## DESCRIPTIVE REPORT

Type of Survey .. Field Examination ..  
Field No. .... DA-10-1-84 ..  
Registry No. ... FE-261 ..

State ..... Alaska ..  
General Locality Gulf of Alaska ..  
Sublocality ... 24 Miles NW of Cape St. Elias ..

PACIFIC MARINE CENTER  
EVALUATION REPORT

ATTACHMENT # D

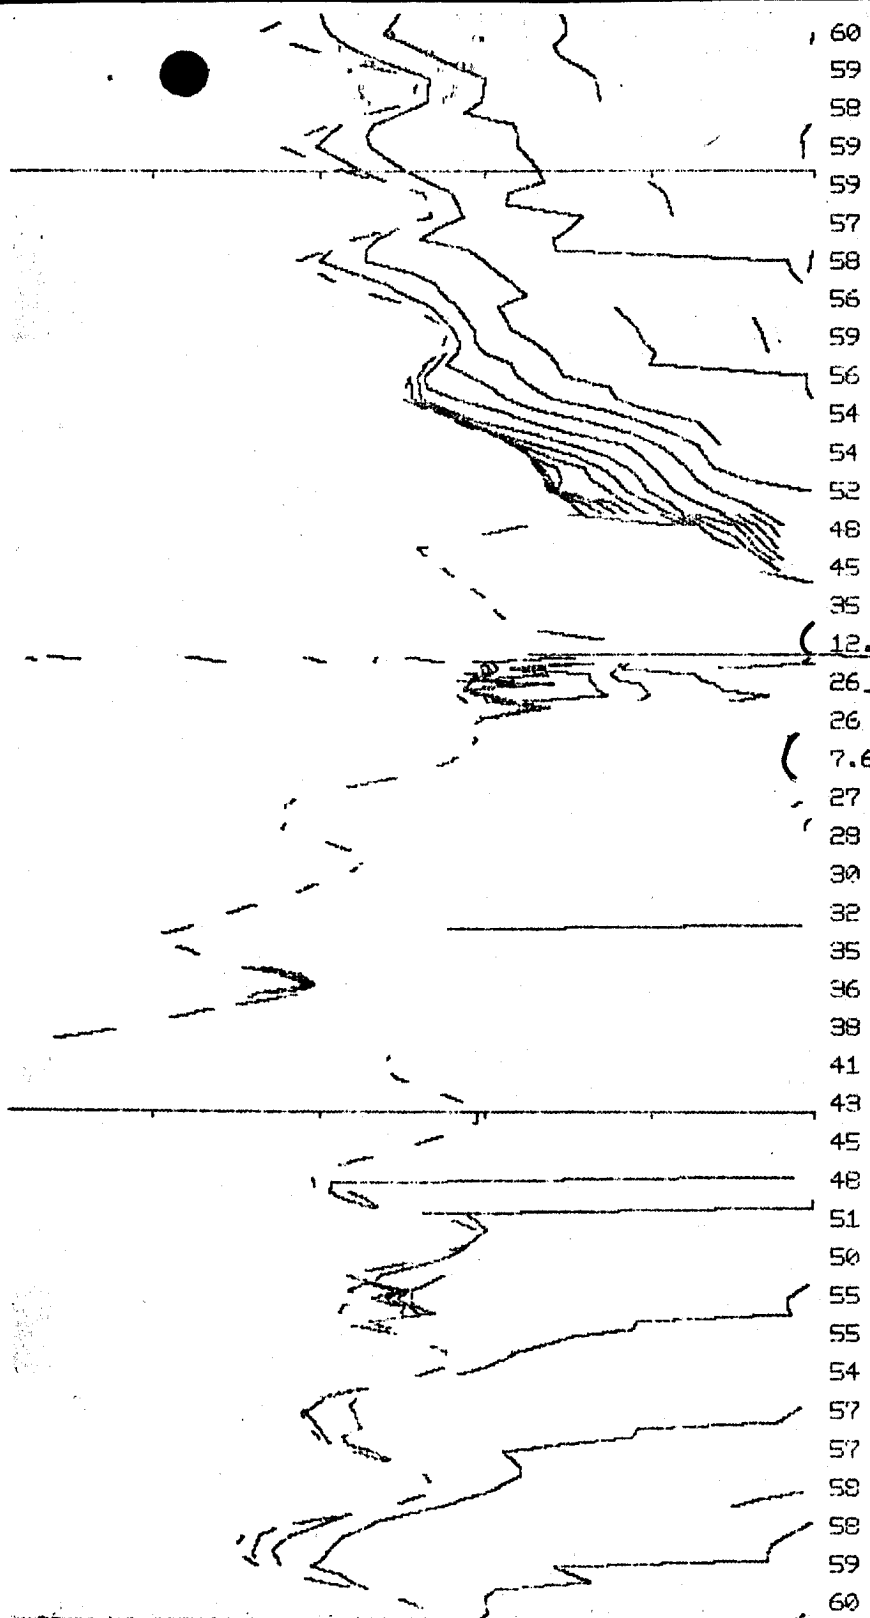
• Shoalst sounding selected by SPLOT.  
same as underlined sounding from beam 6  
on ATTACHMENT C.

FE-261

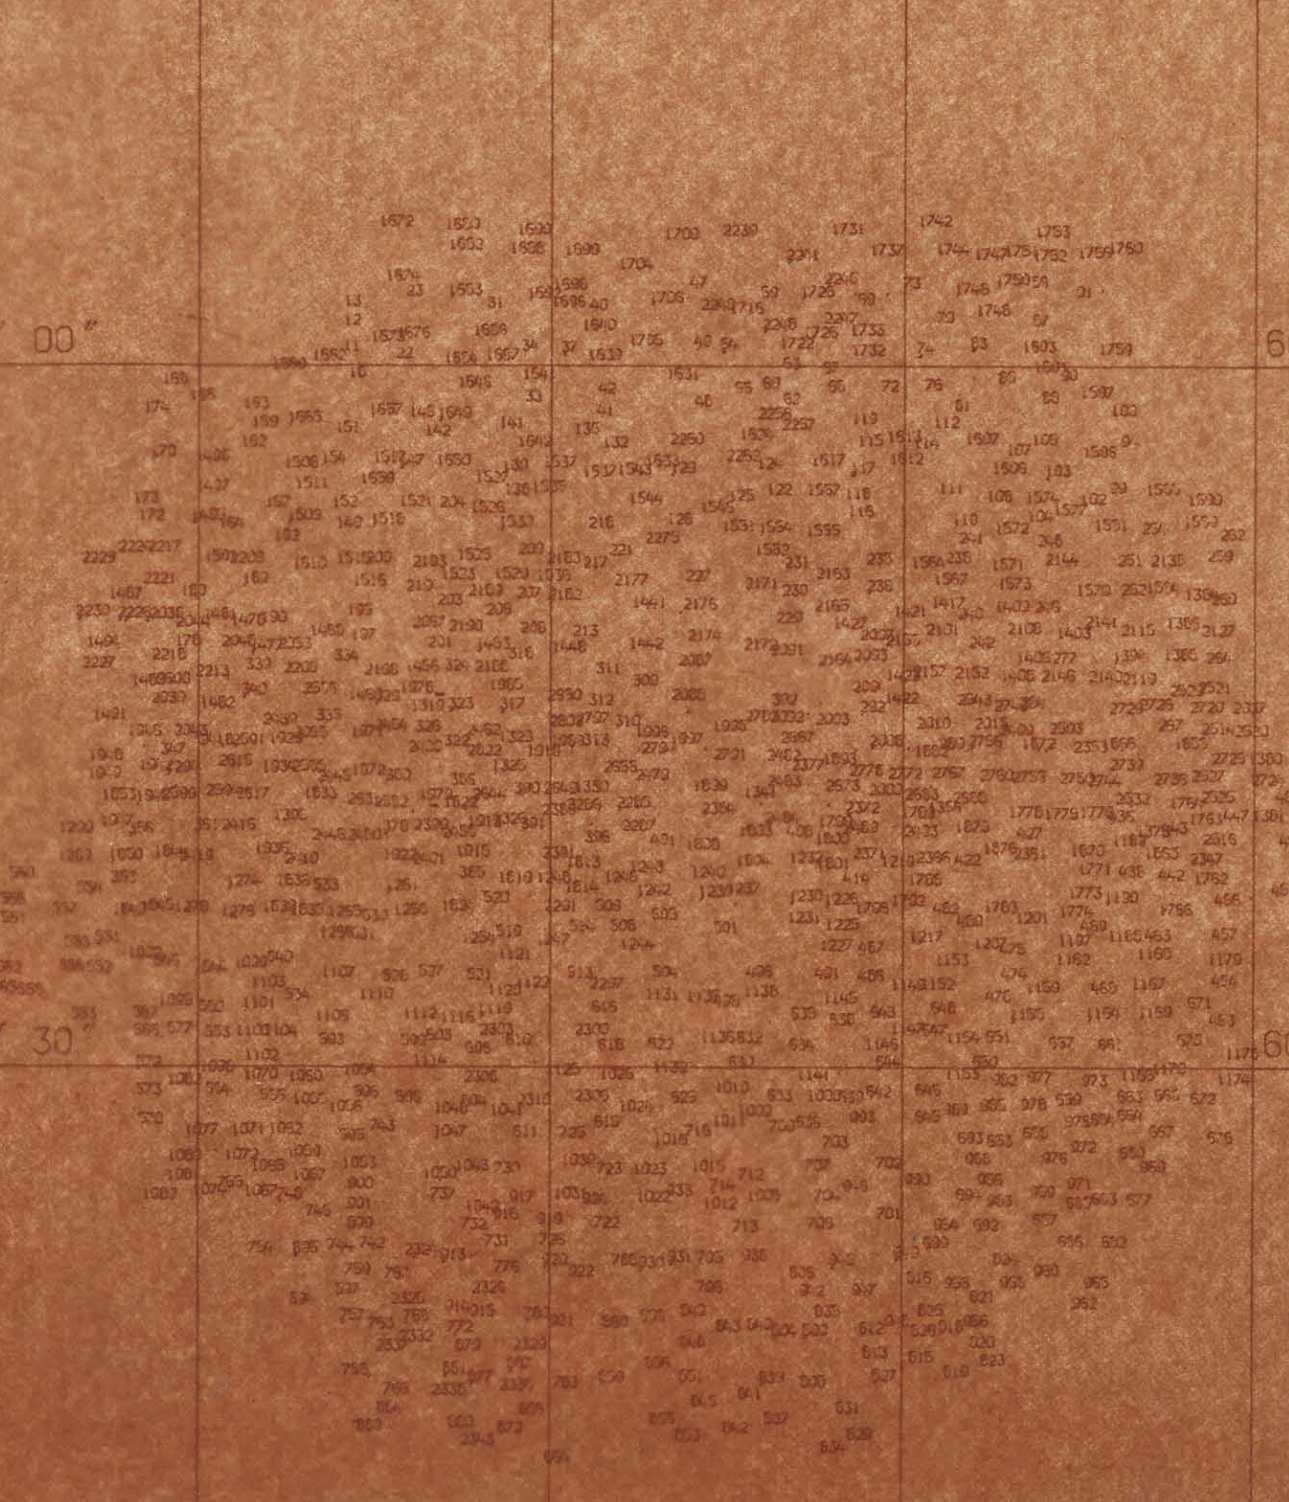
The minimum depth over the shoal as determined by the BS<sup>3</sup> selected data is 10.4 fathoms at latitude 60°00'44.15"N, longitude 145°13'22.73"W. However, shoaler depths were indicated on the center beam of the BS<sup>3</sup> contour plot and by the bridge DSF-6000N fathometer operated concurrently with the BS<sup>3</sup>. These shoaler indications plus the BS<sup>3</sup> operating manual's cautions against operating the BS<sup>3</sup> simultaneously with other sonars and in determining critical least depths over pinnacles, wrecks, and obstructions cast doubt as to whether the minimum depths over the shoal area had been determined by the BS<sup>3</sup>. Therefore, these shoaler depths have been added to the smooth sheet and the survey records, resulting in the addition of the following depths:

- a. 8.2 fathoms at latitude 60°00'43.88"N, longitude 145°13'19.75"W from the BS<sup>3</sup> centerbeam (12.4 fathoms from BS<sup>3</sup> data selection).
- b. 9.6 fathoms at latitude 60°00'41.09"N, longitude 145°13'24.28"W from the wide beam trace of the DSF-6000N echo sounder (12.4 fathoms from BS<sup>3</sup> data selection).

A 7.6 fathom depth and a 12.2 fathom depth in its vicinity were indicated by the BS<sup>3</sup> center beam at latitude 60°00'51.98"N, longitude 145°13'16.18"W.

The BS<sup>3</sup> selected depth of 23 fathoms at this position is supported by the DSF-6000N fathometer. Therefore, the 7.6 fathom and 12.2 fathom depths have not been added to this survey and the 23 fathom BS<sup>3</sup> selected depth retained on the smooth sheet.
